Subject: Chapter 343, Hawaii Revised Statutes (HRS)
Final Environmental Assessment (EA) Determination
Finding of No Significant Impact (FONSI)

Name of Project:	Heinz Shoreline Protection Replacement and Retaining Wall Reconstruction
Applicable Law:	Section 343-5(a)(3), HRS; Section 11-200-6(b)(1)(C), HAR
Type of Document:	Final Environmental Assessment
Island:	O'ahu
District:	Ko'olaupoko
TMK:	4-7-19: 76 and 80
Permits Required:	Shoreline Setback Variance, U.S. Army Corp Permit, Building Permit
Name of Applicant or Proposing Agency:	Ursula Heinz, MD Ursula Heinz Trust
Address	47-119 Kamehameha Hwy.
City, State, Zip	Kāne'ohe, Hawaii 96744
Approving Agency:	City and County of Honolulu
Address	Department of Planning and Permitting
City, State, Zip	650 South King Street, 7 th Floor
Contact and Phone	Honolulu, Hawaii 96813 Steve Tagawa (808) 768-8024
Consultant	Oceanit Laboratories, Inc
Address	828 Fort Street Mall, Suite 600
City, State, Zip	Honolulu, Hawaii 96813
Contact and Phone	Warren Bucher, PhD, PE (808) 954-4114

Final Environmental Assessment

Heinz Sea Wall Repair Kane'ohe Bay, O'ahu, Hawai'i

Figure 13. Site Plan with House, Walls, Gazebo, and Shoreline Setback

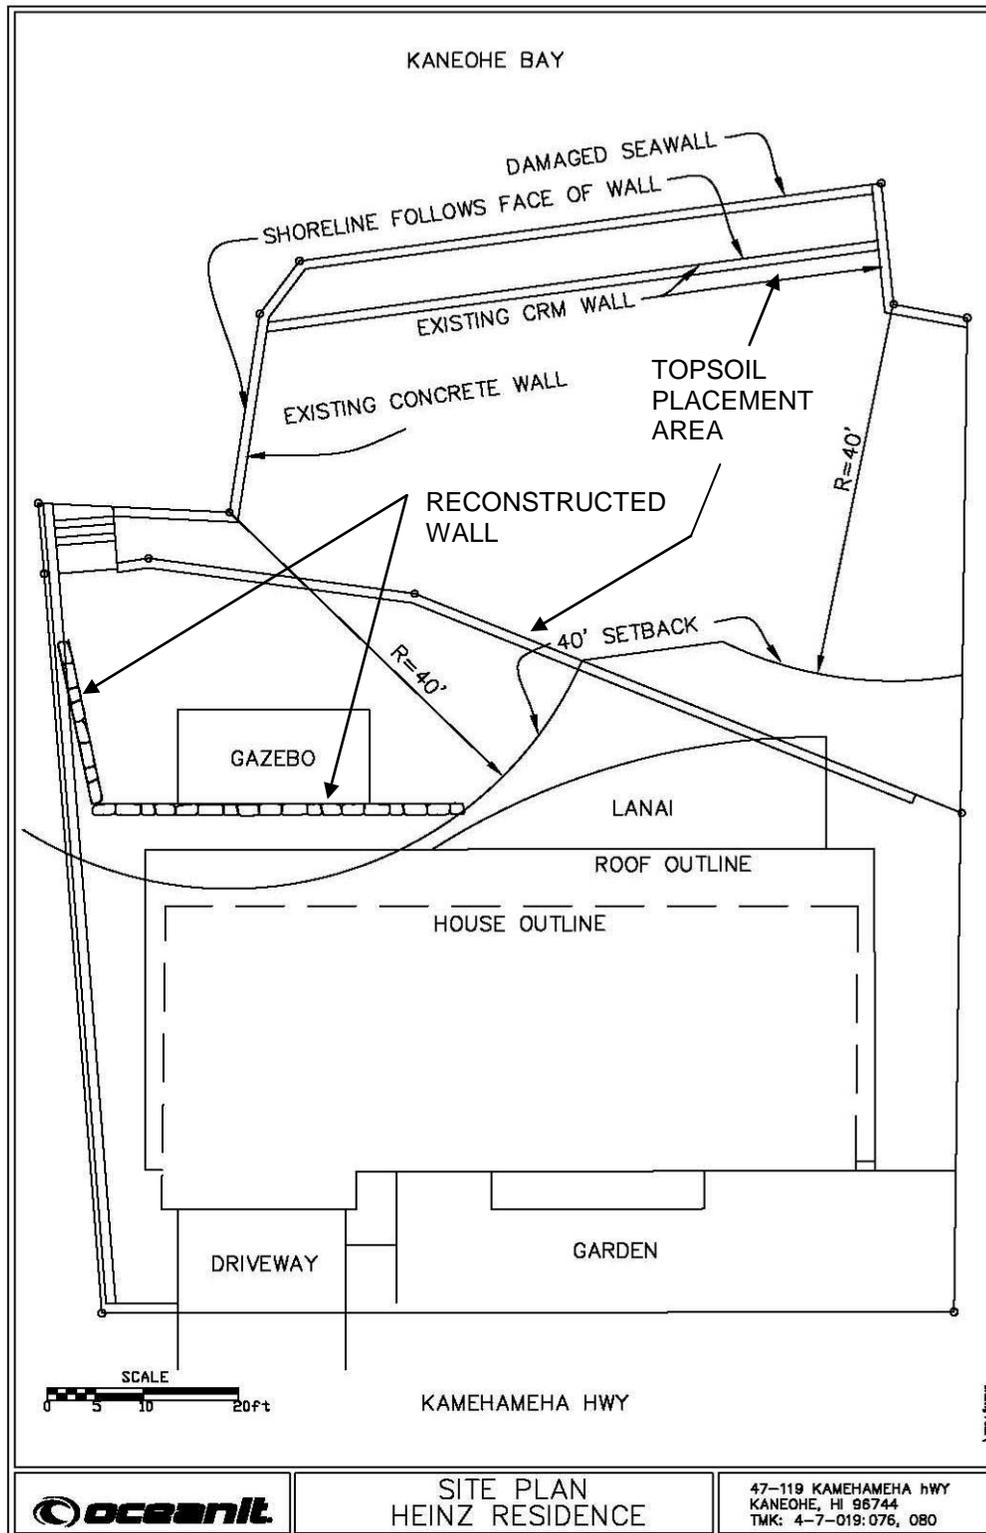
The Site Plan (Figure 10) should be revised to delineate the 40-foot shoreline setback line and show all improvements, including side walls. The EA should also provide a complete description of the site, which includes the existing dwelling and its distance from the shoreline. Please note that any improvements, which were not disclosed in the EA nor included in an SV approval, may not be retained unless they have previously been recognized by DPP as nonconforming.

The site plan shown in Figure 10 of the DEA will be modified to show the setback line, the existing house, and other improvements.
